FINAL DRAFT MINUTES

March 20, 2014 Standards Committee Meeting

REVISION TO STANDARD SPECIFICATIONS, SPECIAL PROVISIONS AND DRAWINGS
REVISION TO STANDARD DRAWINGS

STANDARD DRAWINGS 802-SNGP 01 THRU -14; 802-SNDH-01 AND -02

802-SNGP-01 SIGN PLACEMENT WIDE FLANGE SIGN SUPPORT (REVISED DRAFT)

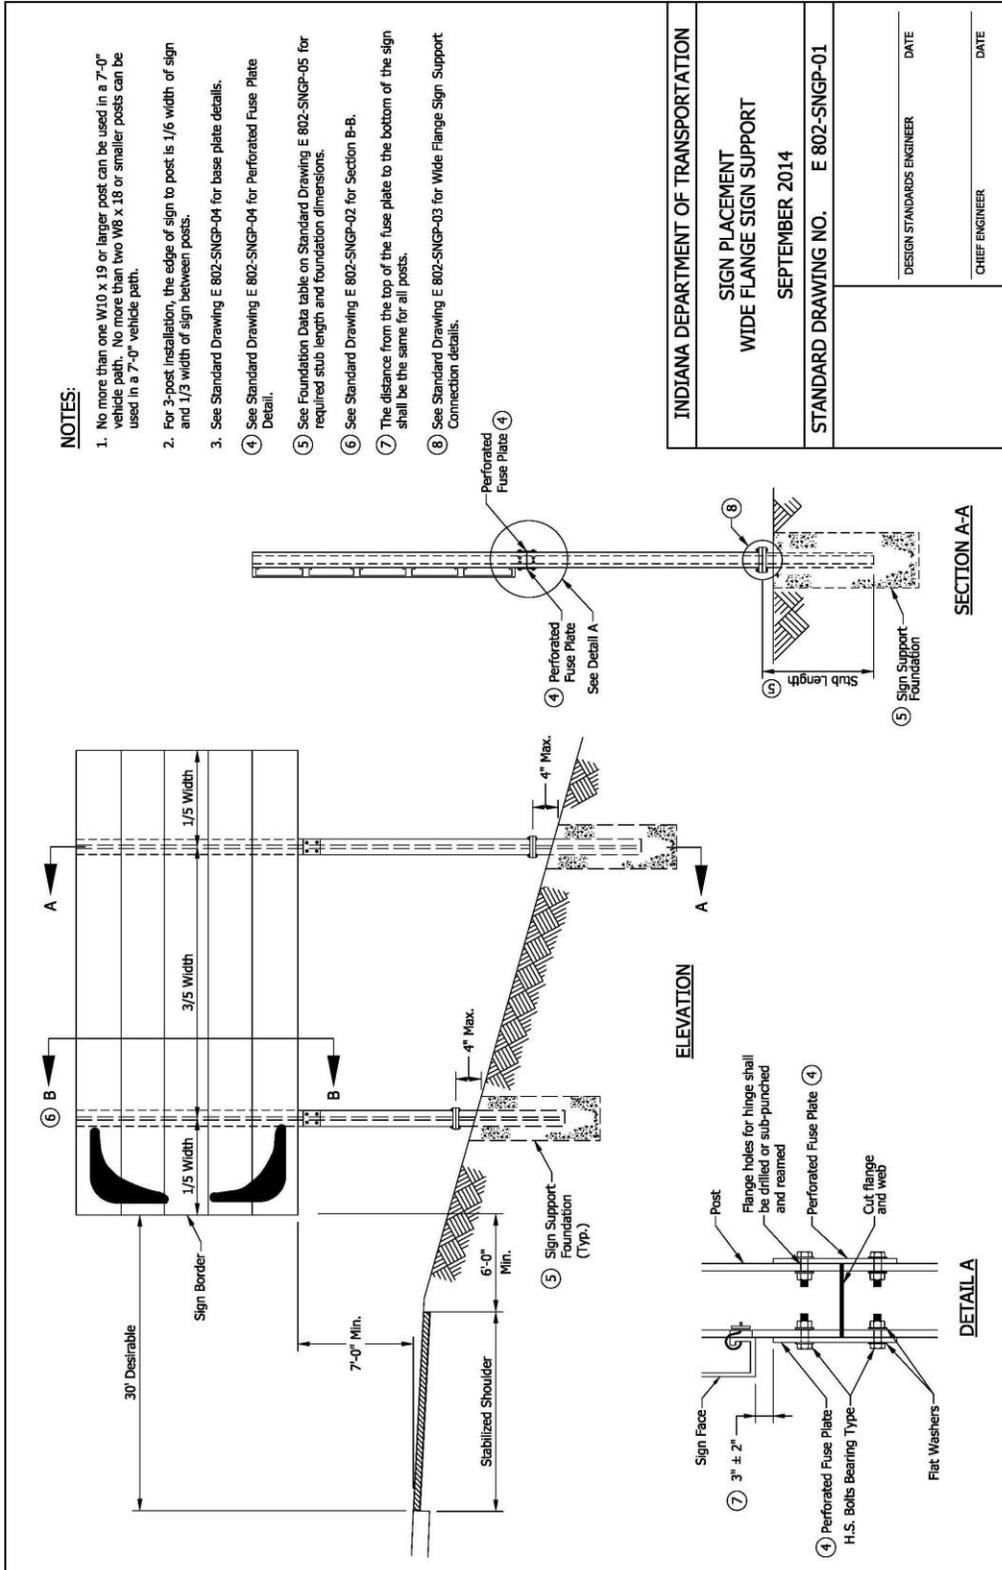
Mr. Miller asked about note 1 on sheet E 802-SNGP-01, concerning the distance between posts. Mr. Pankow offered clarification that there are to be no more than two posts within 7 ft of each other. Mr. Miller asked if that information should be in the design manual, instead of on the standard drawing, and if designed correctly, that note would not be necessary. Further discussion ensued concerning sign design and layout and placement. Following the discussion, it was determined to leave the note with adding a word "vehicle".

DISCUSSION: This item was introduced and presented by Mr. Boruff who stated the reasoning behind these standard drawing revisions, as shown on the proposal sheet. Mr. Boruff further explained some of the drawing revisions shown. Mr. Garg handed out revised drawings for E 802-SNGP-04 and -05 showing plate and shim details which clarify the washer type and thickness. Also revised is drawing E 802-SNGP-01, which clarifies Note 1 regarding the 7 ft wide vehicle path.

802-SNGP-03 SIGN PLAN DETAILS (WITH MARKUPS)

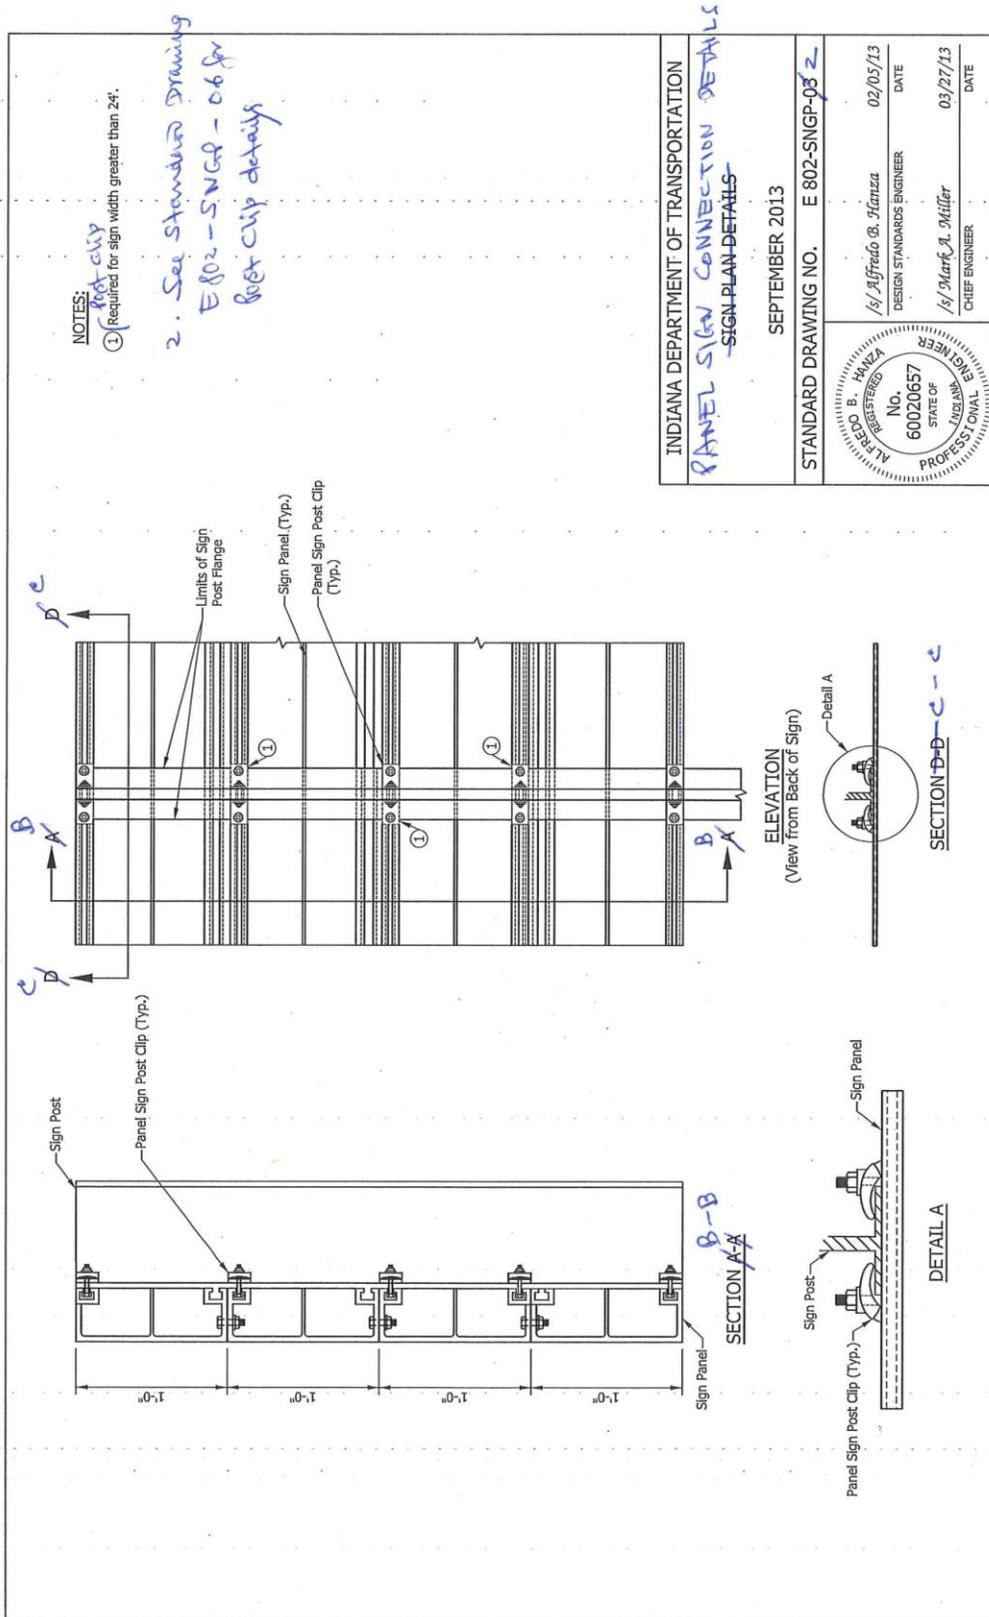
PROPOSED SOLUTION: Revise Standard Drawing 802-SNGP-13 and place in a new series, 802-SNDH. Also move 802-SNGP-11 into the new series and eliminate 802-SNGP-12 and 802-SNGP-14.

802-SNGS-12 WIDE FLANGE POST SELECTION TABLE (WITH MARKUPS)

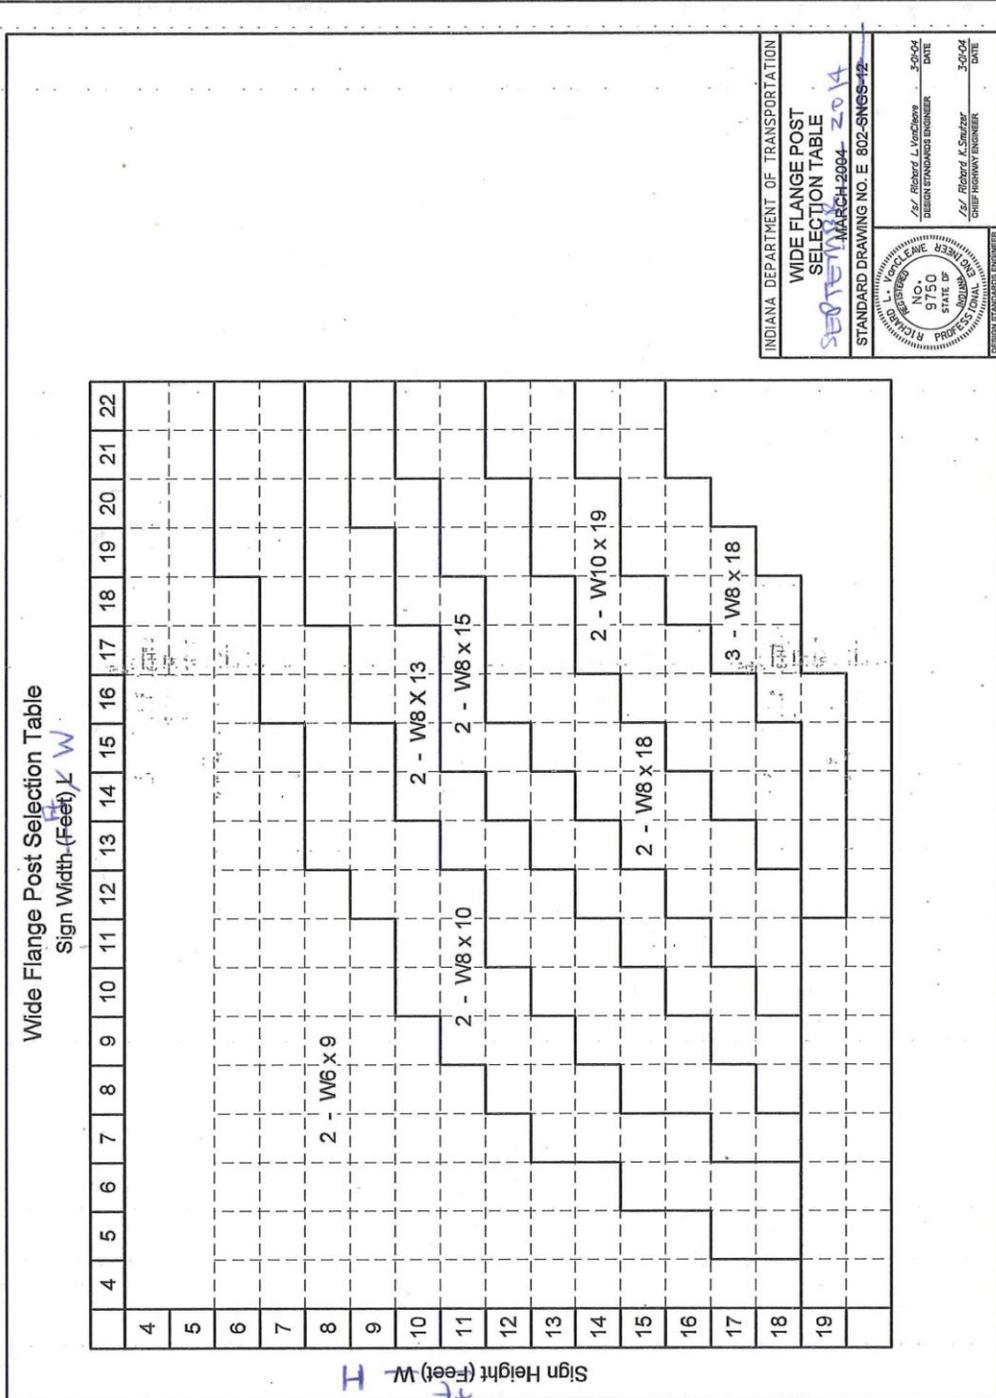
Move 802-SNGS-12 to the 802-SNGP panel sign series.

802-SNGP-12 SIGN PLACEMENT (WITH MARKUPS)

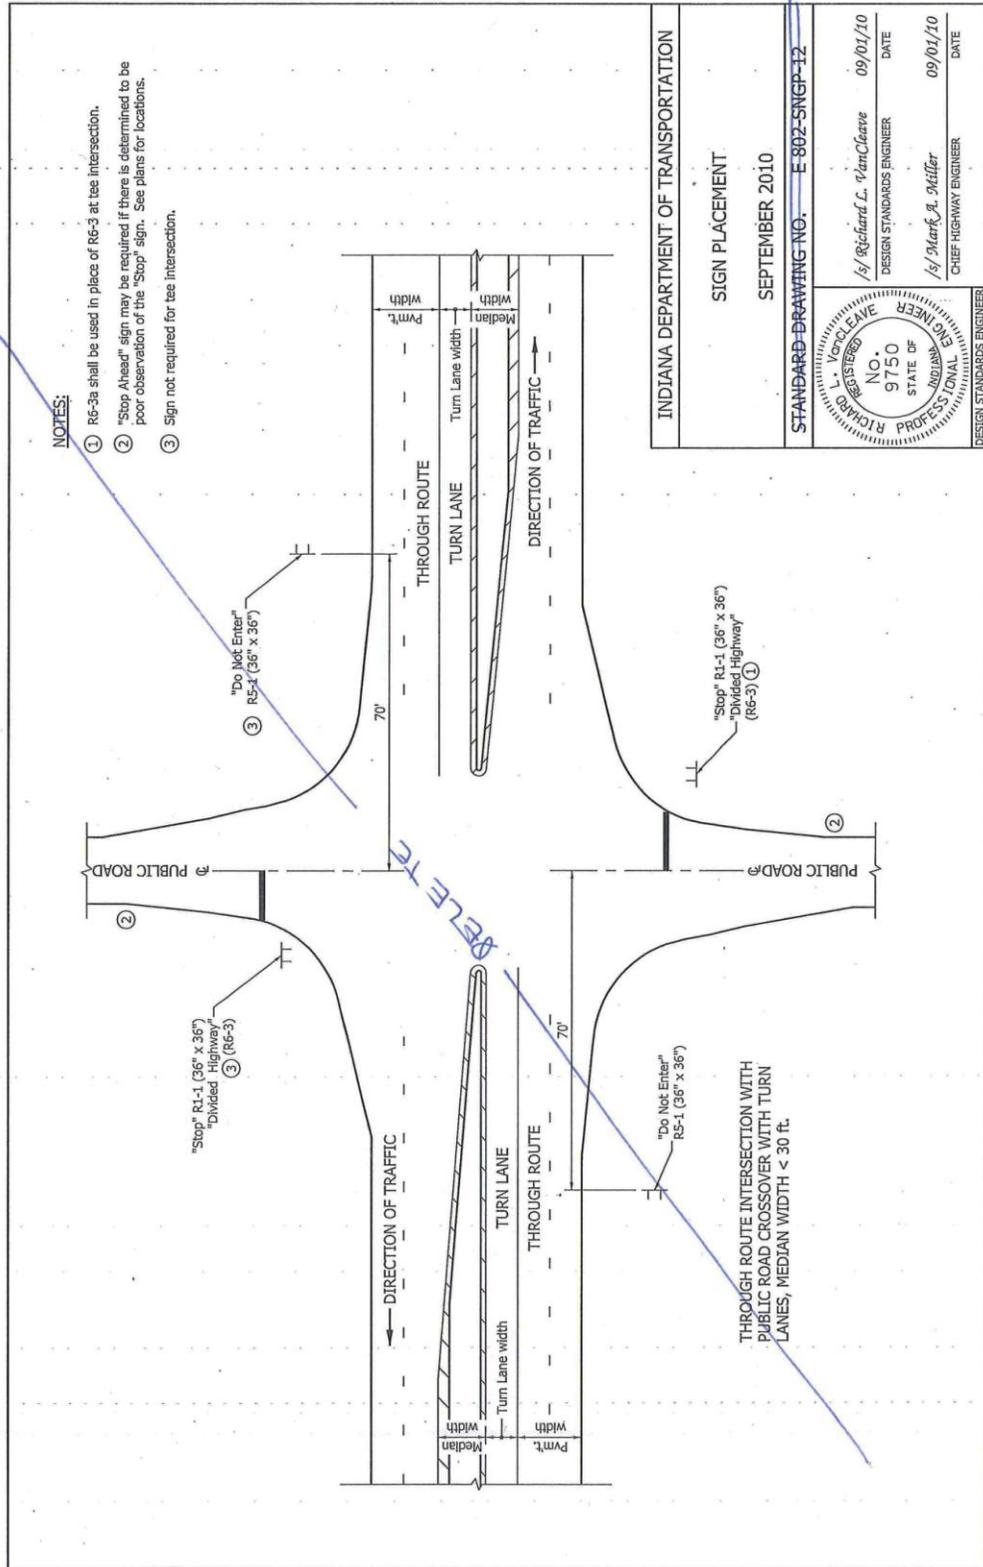
1. 802-SNGP-11 and 802-SNGP-12 show identical signing
2. 802-SNGP-13 and 802-SNGP-14 also show identical signing
3. 802-SNGP-05, 802-SNGP-06, 802-SNGP-07 which show sign post and foundation data can be condensed.

802-SNDH-13 SIGN PLACEMENT (WITH MARKUPS)

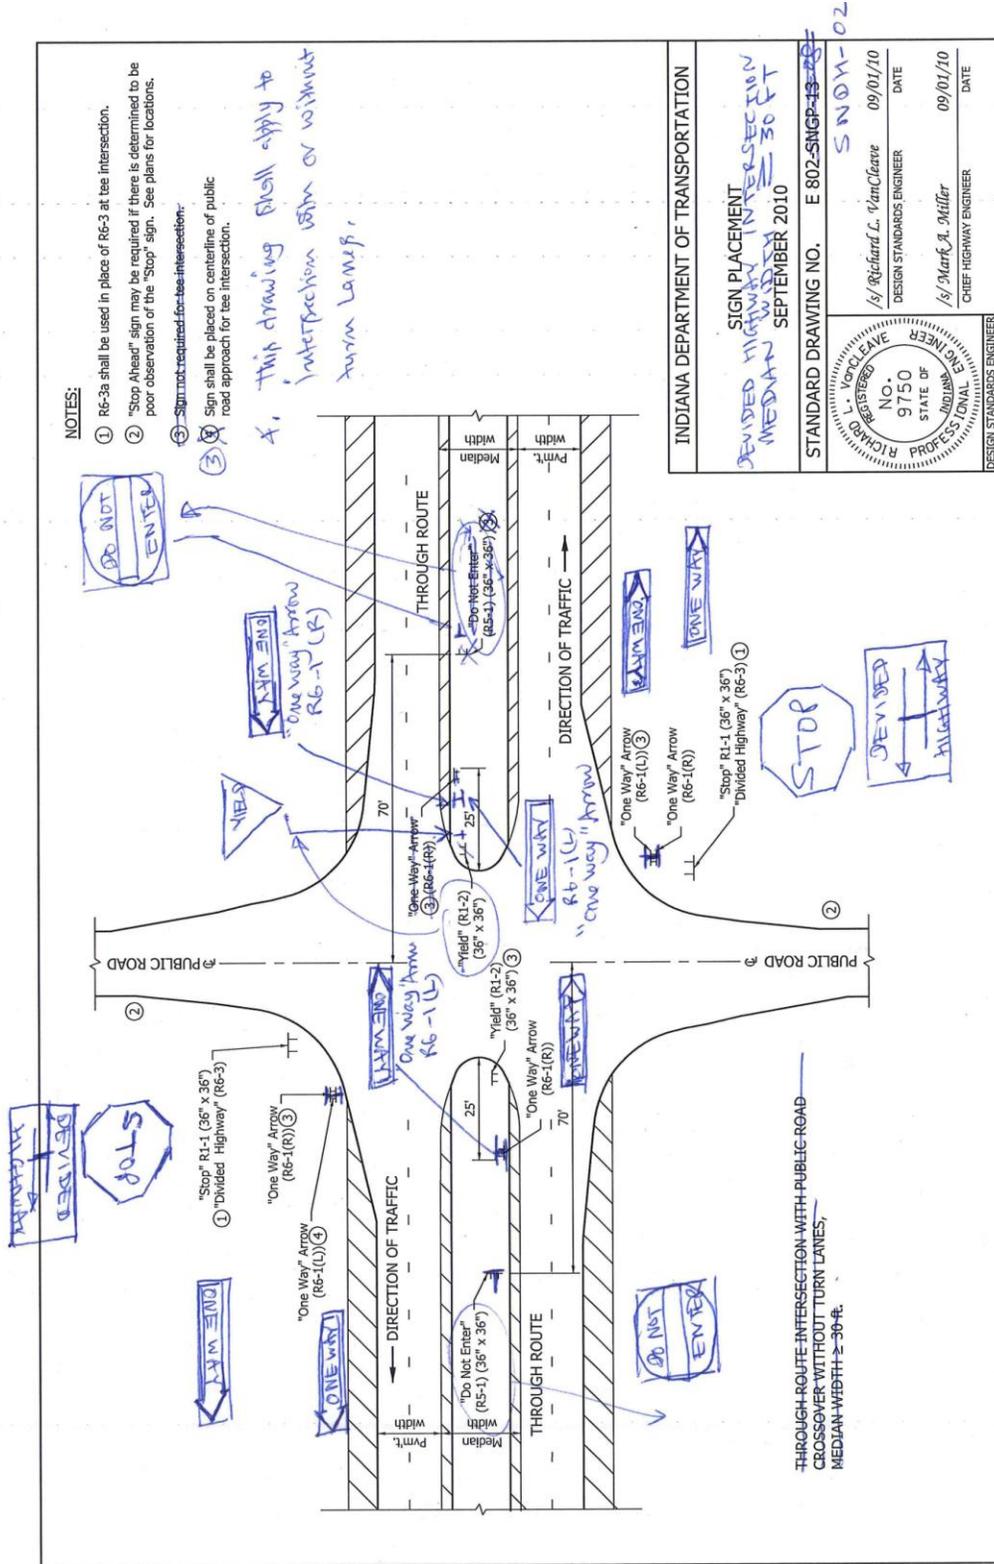
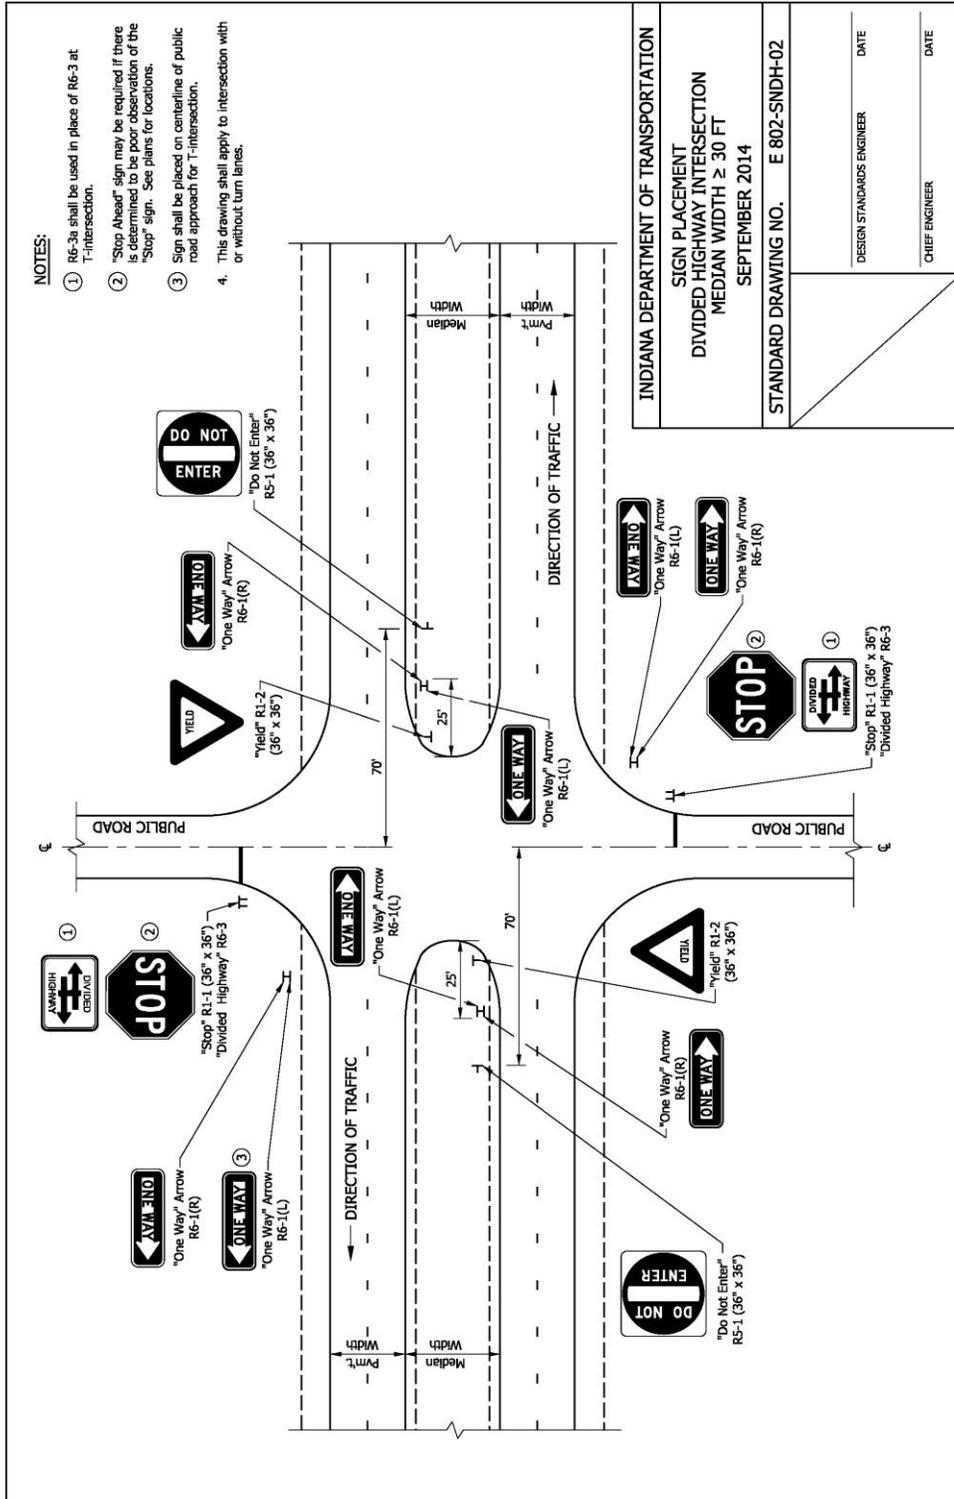
PROBLEM(S) ENCOUNTERED: Standard Drawings 802-SNGP-13 and 802-SNGP-14 showing Sign Placement for divided highway intersections with medians 30 ft or wider do not include the ONE WAY signs in the median that are required by the 2011 IMUTCD.
